PEAVEY ELECTRONICS INC.			
TITLE: XR1212 Amplifier			
DRAWN: jdb	DATED: 10/08/07	CODE:	REV: 02
CHECKED:	DATED:	SIZE:	DRAWING NO:
QUALITY CONTROL:	DATED:	SCALE:	SHEET: 1 OF 1
RELEASED:	DATED:

PEAVEY ELECTRONICS INC.			
TITLE: Power Supply			
DRAWN: F.D.B.	DATED:	CODE:	REV:
CHECKED:	DATED:	SIZE: D	DRAWING NO.:
QUALITY CONTROL:	DATED:	SCALE:	SHEET: 2 OF 2
RELEASED:	DATED:

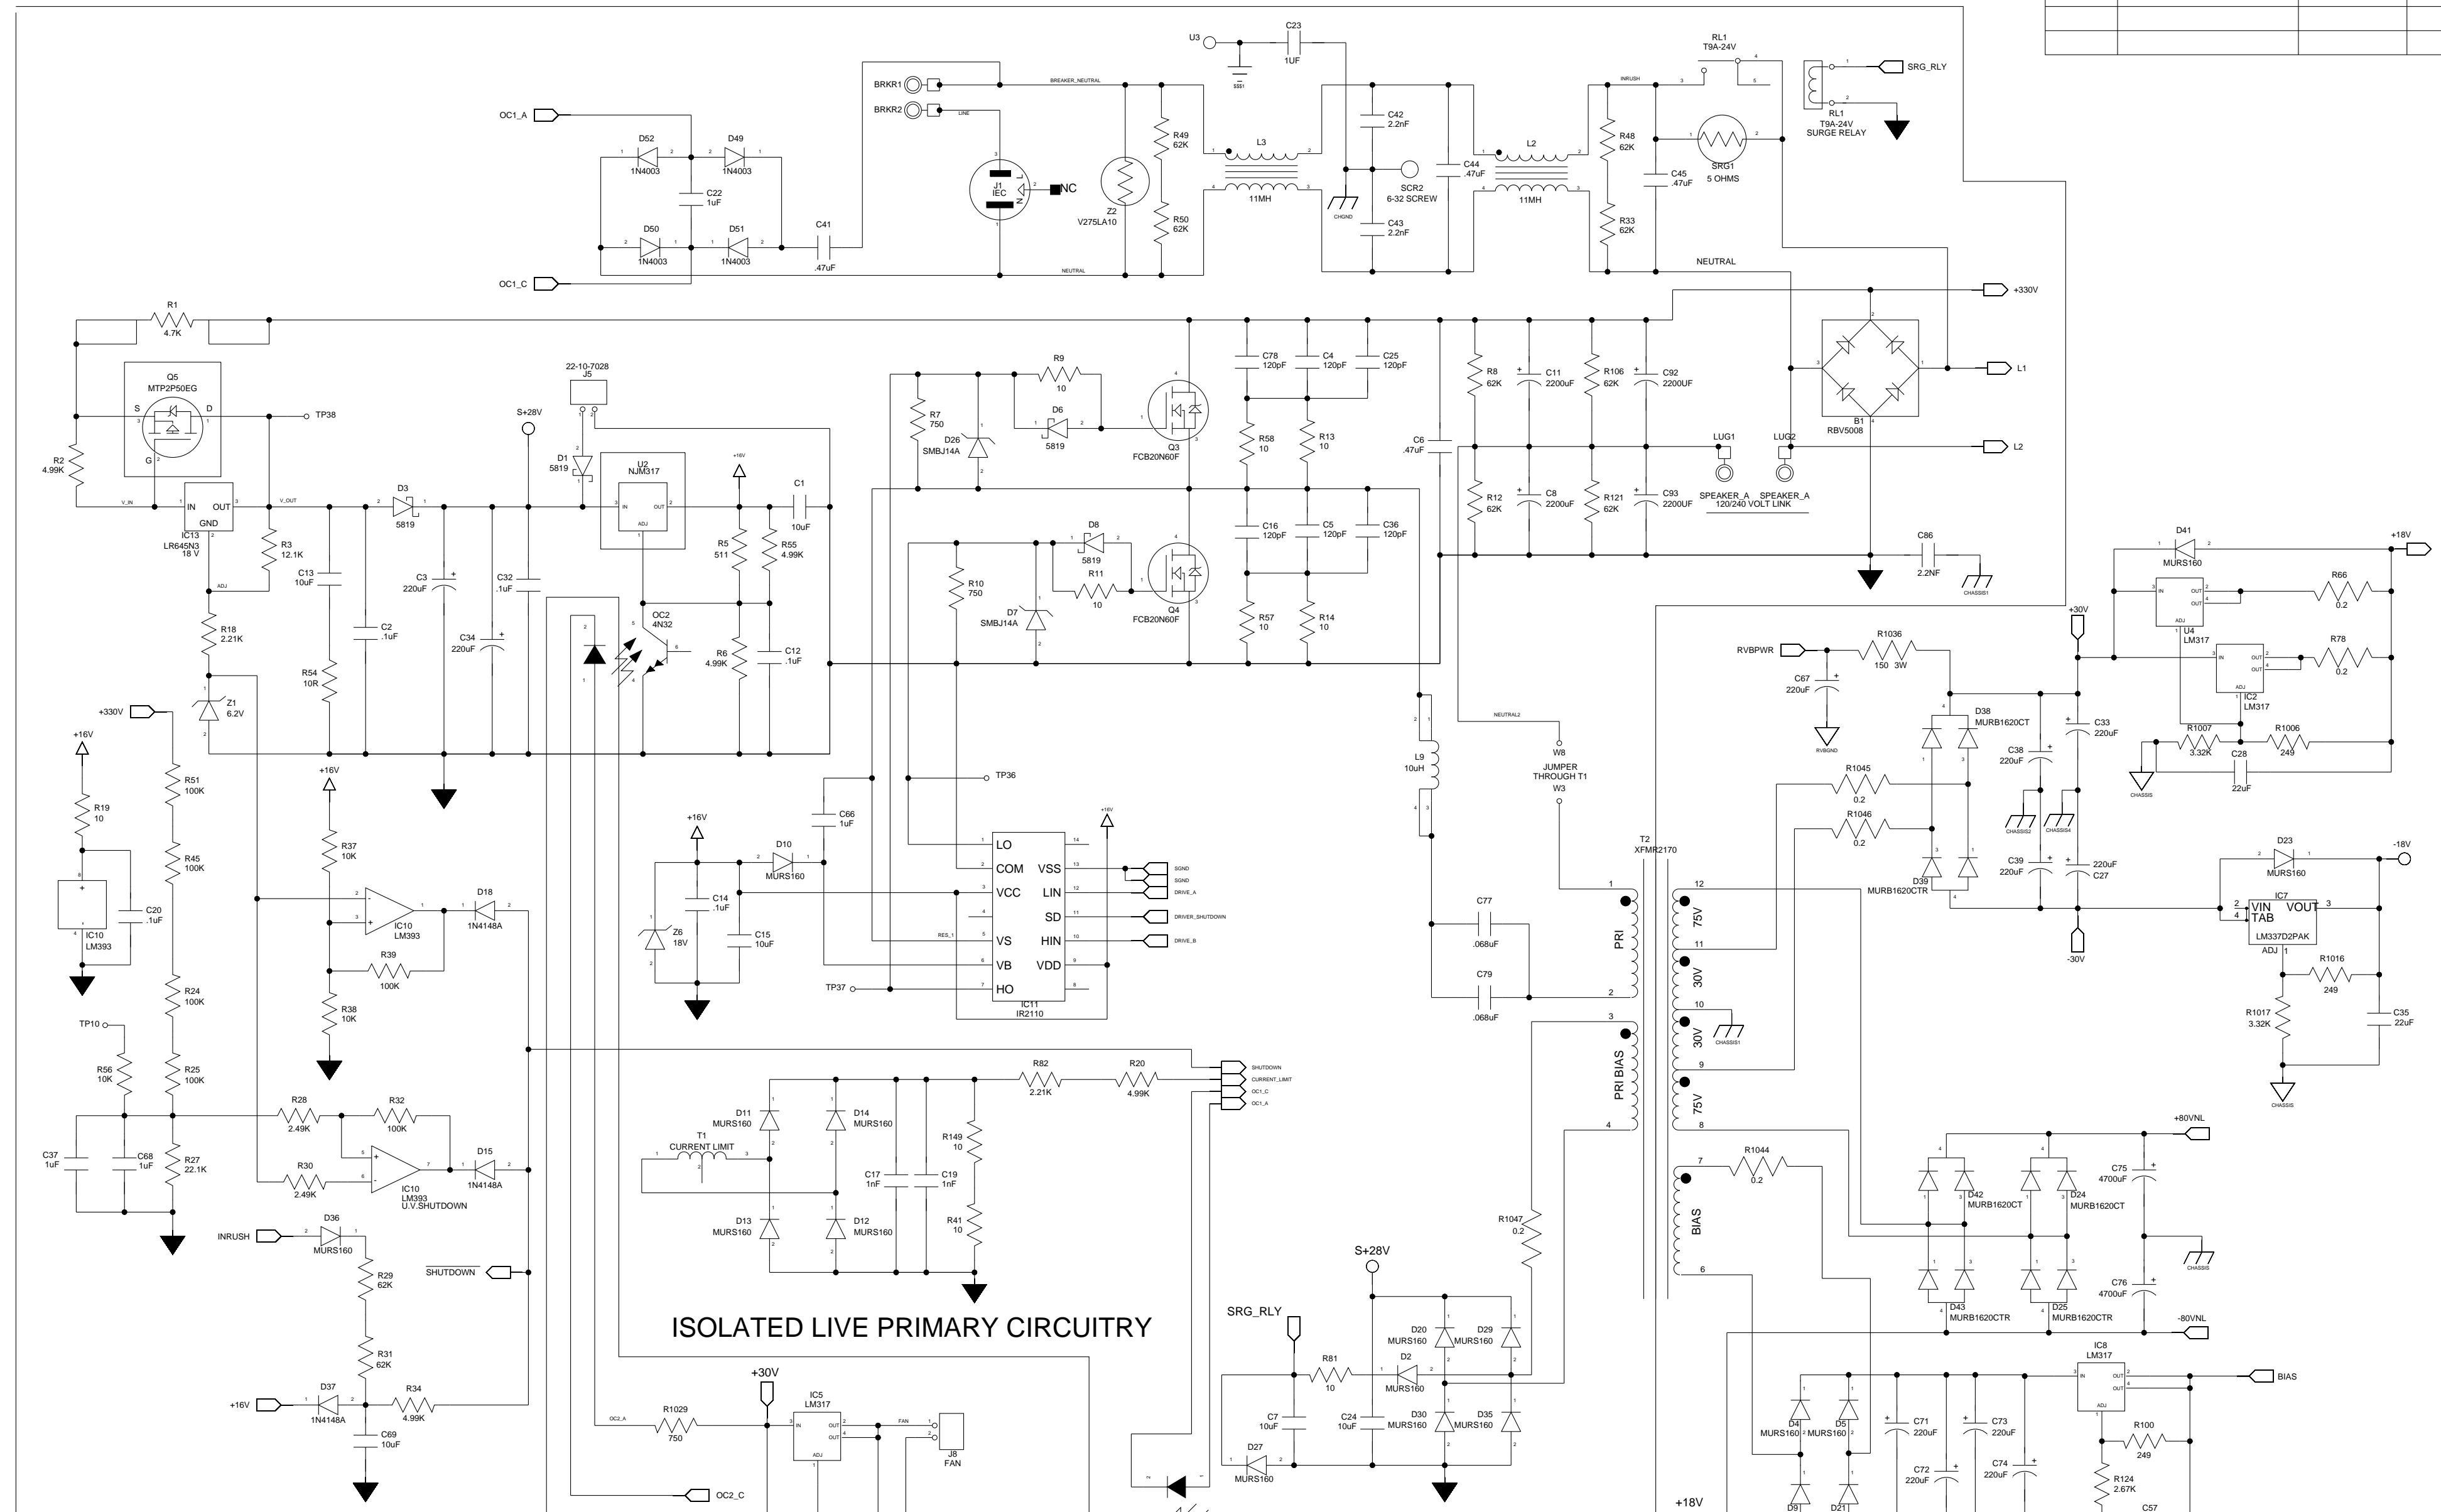
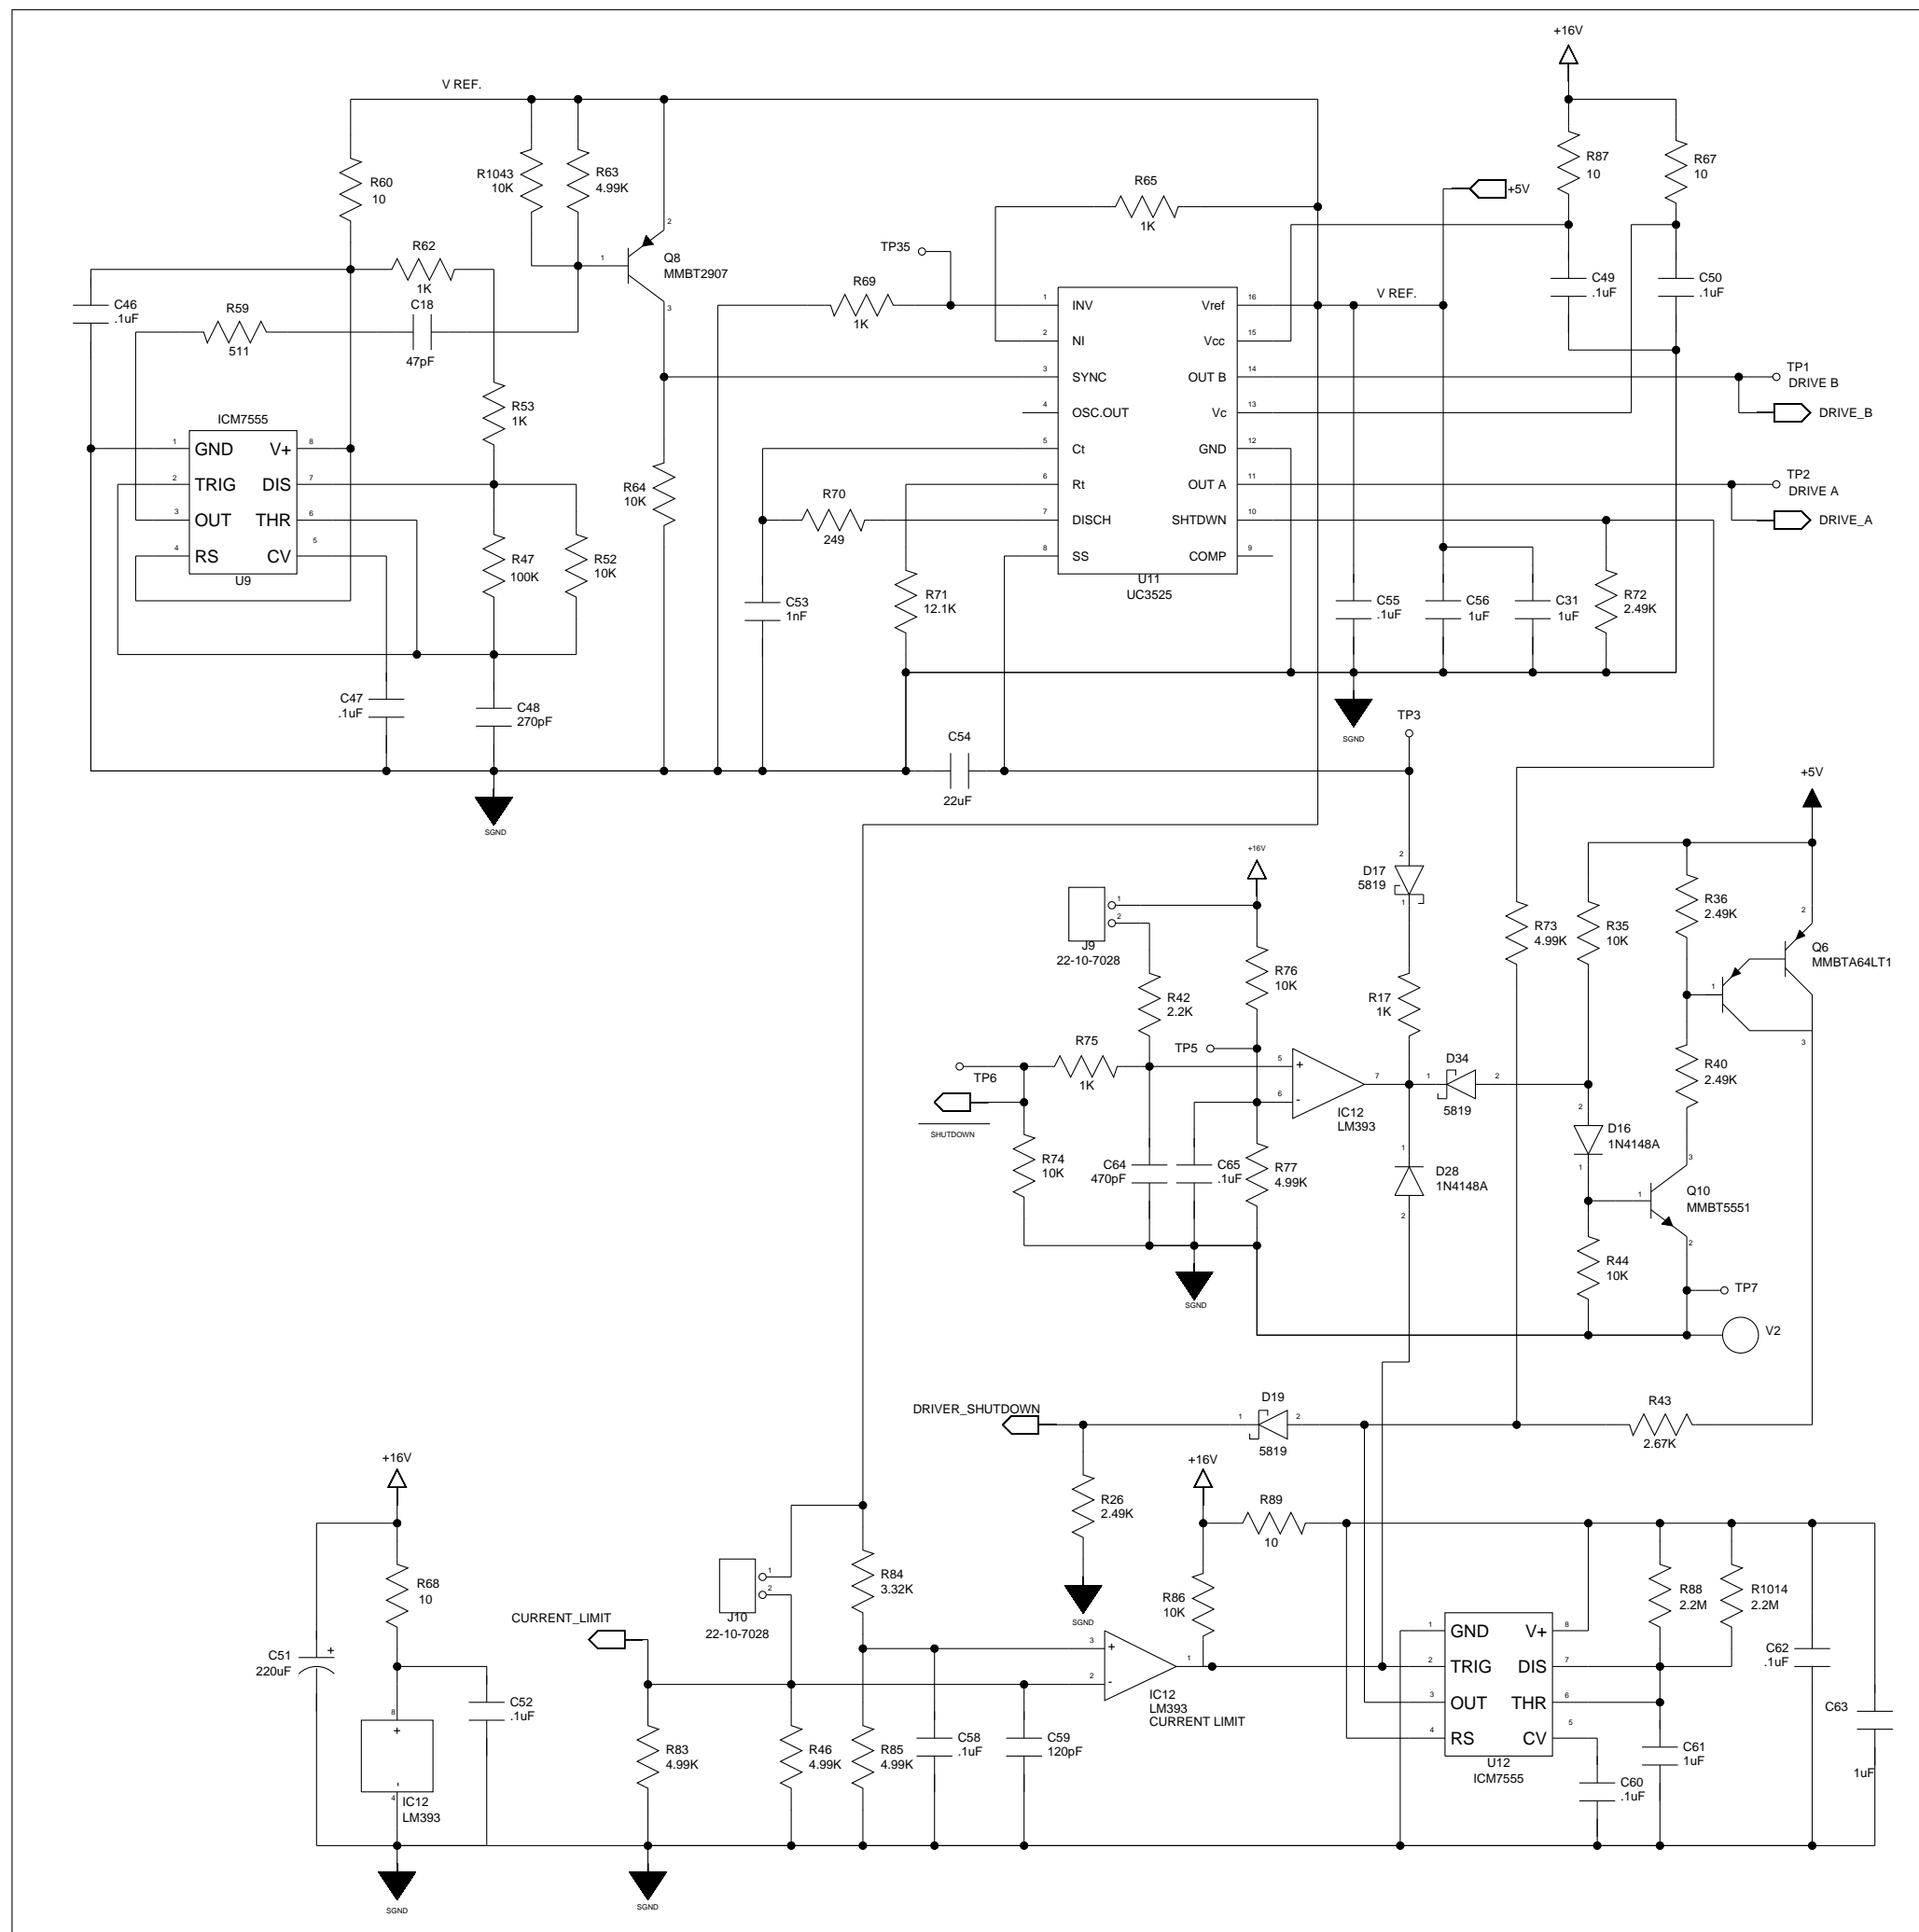
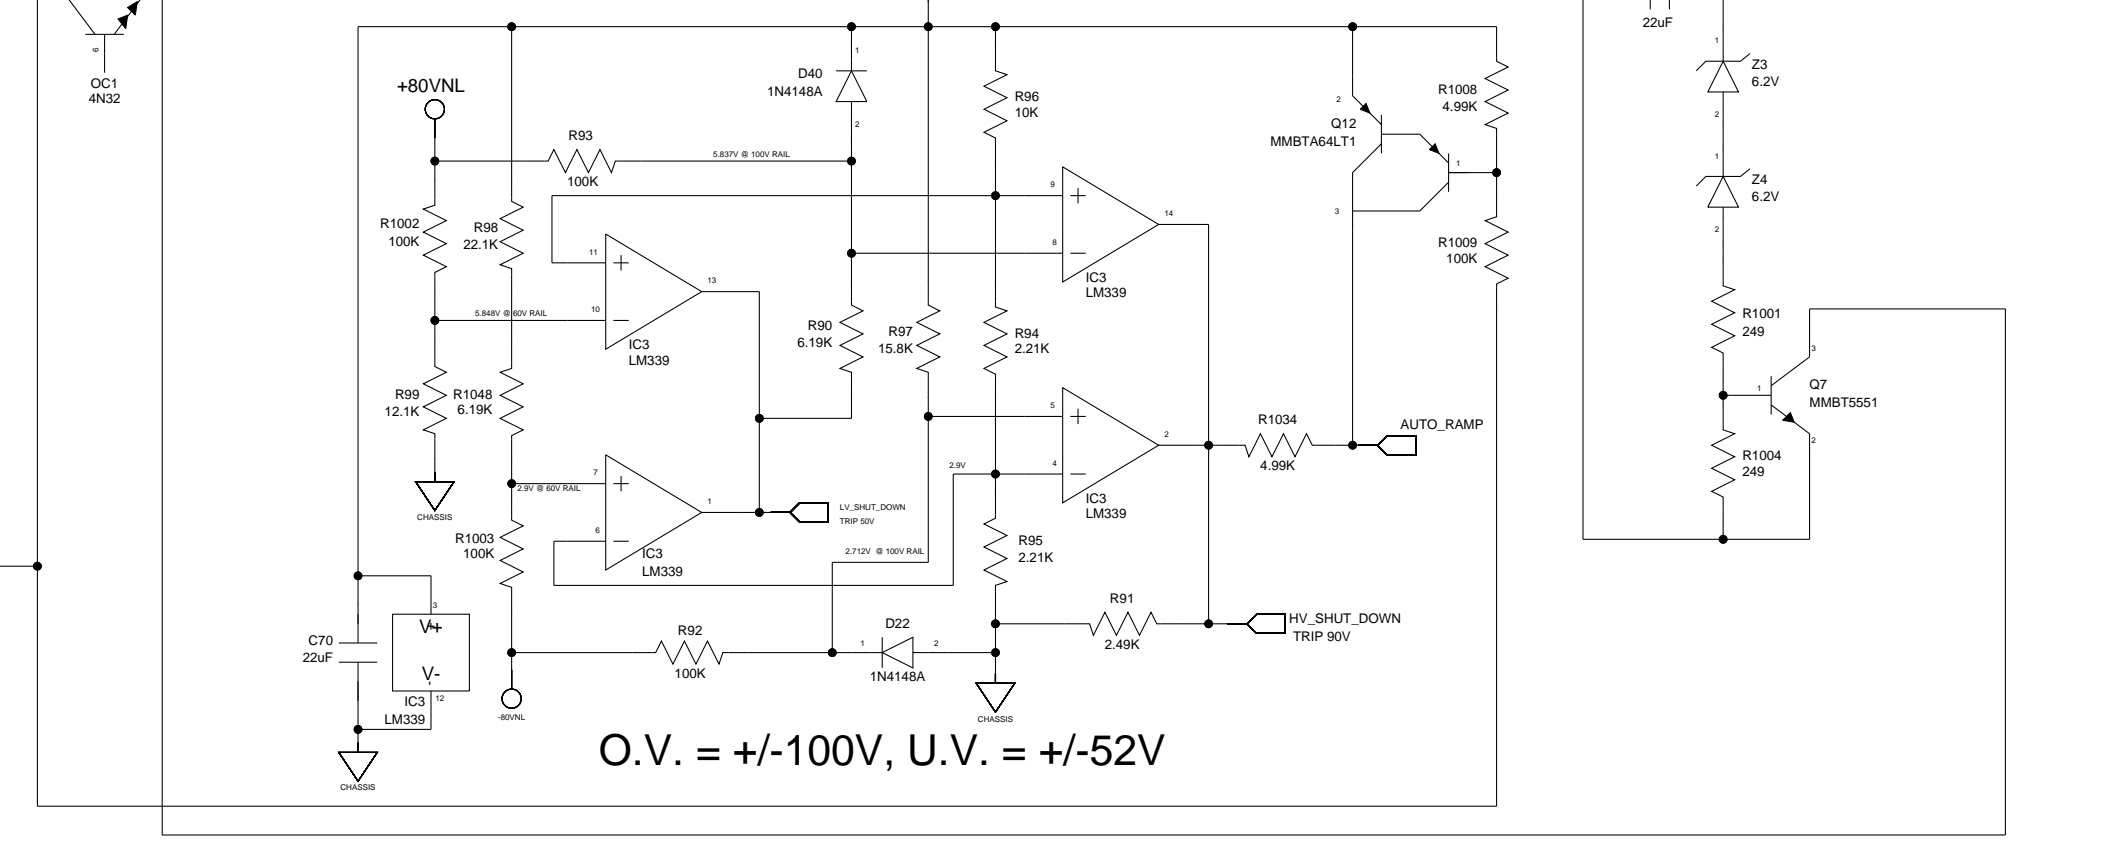
DELETE Q102, R121, R122 FOR MIXER VERSION  
DELETE Q100, R131, R130 FOR MIXER VERSION  
DELETE Q202, R221, R222 FOR MIXER VERSION  
DELETE Q200, R231, R230 FOR MIXER VERSION  
9/10/07 CHANGE Rx42 & Rx44 TO 1K FOR 4 OHM LIMIT FOR MIXER VERSION

8/8/07 ADDED 47.5K ACROSS Cx29  
9/19/07 DELETED SNUBBER PARTS R61, R66, R78, R79, R80, C77, C79, C21  
9/4/07 CHANGED Rx14 CONNECTION  
6/4/07 CORRECTED R73 TRACK ERROR  
6/4/07 CORRECTED BRIDGE ROUTING  
7/25/07 DELETED Cx14  
9/4/07 CHANGED J4 & J7  
8/7/07 CHANGED L9 TO 18.5uH 30500891  
8/7/07 CHANGED ICx04 TO LM358  
9/13/07 CHANGED R99 FROM 13.3KTO 12.1K 30200376  
9/13/07 CHANGED R3, R71 R99 FROM 1206 TO 0805 30200376  
9/12/07 PENDING .... CHANGE LCI INDUCTORS TO 8mH  
9/12/07 CHANGED Rx33 & Rx34 TO FROM 22 TO 10 OHMS 30200239  
6/12/07 CHANGED C22 FROM .47uF 30300253 TO .068uF  
9/12/07 CHANGE R243 TO 4.99K 30200173  
9/12/07 ADDED Rx56 & Rx60 10 OHMS 30200239 IN SERIES WITH Rx33 & Rx34  
8/7/07 CHANGED Rx20 FROM 221 TO 200 30200373  
8/5/07 CHANGED Rx42 & Rx44 FROM 4.99K TO 2K 30200204  
9/4/07 ADDED TEMP AND DC LEDS + CIRCUITRY. DELETED PILOT  
6/12/07 CHANGED C48 FROM 470pf 30300090 TO 270pF.

8/15/07 CHANGED Cx05 FROM 150pF 30300065 TO 100pF 500V 1210 2%  
8/24/07 CHANGED VALUE OF R80, R79, R78, R66, R61 FROM 10R TO 22R  
9/4/07 CHANGED Rx50 & Rx58 FROM 24.3K 0.1% TO 16K 1%  
9/13/07 CHANGED R1048 ROM 1.21KTO 6.19K  
6/4/07 CHANGED Rx47 FROM 1.5K 30200284 TO 2.67K 30200470  
8/17/07 CHANGED Cx01, Cx03, Cx07 TO 1%  
8/14/07 DELETED RX86 (DC PROTECT GATE RESISTORS)  
8/8/07 CHANGE GATE RESISTORS TO 6.8R  
9/10/07 FOR 24V FAN, ADD Z7. BYPASS FOR 12V FAN.  
8/21/07 C26 CHANGED FROM 220uF TO 1000uF 30300082  
9/13/07 CHANGED R98 FROM 16KTO 22.1K 30200256  
9/14/07 BYPASS R82 AND CHANGE R20 TO 4.99K 30200173  
8/6/07 CHANGED R90 FROM 6.81K 30200328 TO 6.19K  
8/6/07 CHANGED R97 FROM 17.4K 30200428 TO 15.8K  
8/7/07 ADDED NEGATIVE TO GROUND ANTI SPIKE DIODE  
8/1/07 CHANGED RED PROTECT LEDS TO GREEN  
8/6/07 CHANGED Rx04 FROM 221 30200183 TO 1.5K 30200284  
7/31/07 ADDED Cx10 1nF 30300174  
9/14/07 CHANGED R42 FROM 2.49K TO 2.21K 30200236

9/14/07 MOVED BREAKER TO LINE SIDE  
9/14/07 FOR MIXER, CHANGE R82 TO 200 OHMS 30200373  
9/14/07 ADDED Q1, Q2, R1012, R1013, D38, AND D42  
9/14/07 CHANGED CONNECTION TO Cx29  
9/17/07 RENAMED C22 TO C82 AND ADDED C83  
9/17/07 DELETED R4  
9/17/07 CHANGED R43 TO 2.67K 30200413  
9/17/07 ADDED C22, D49, D50, D51, D52  
9/17/07 CHANGED OC1 & OC2  
9/21/07 CHANGED Rx04 to 3.48K  
9/21/07 Deleted VRx00  
9/24/07 Changed R1009 from 10K to 100K  
9/24/07 Changed R1008 from 2.21K to 10K  
9/24/07 Deleted Q9, R143, R243, C81  
9/24/07 Changed R23 to 100K  
9/24/07 Added C21 & D32  
9/26/07 Changed Rx21 and Clip LED connection  
9/26/07 Changed Rx31 and Active LED connection  
9/28/07 Replaced R1 with R1056 - R1069
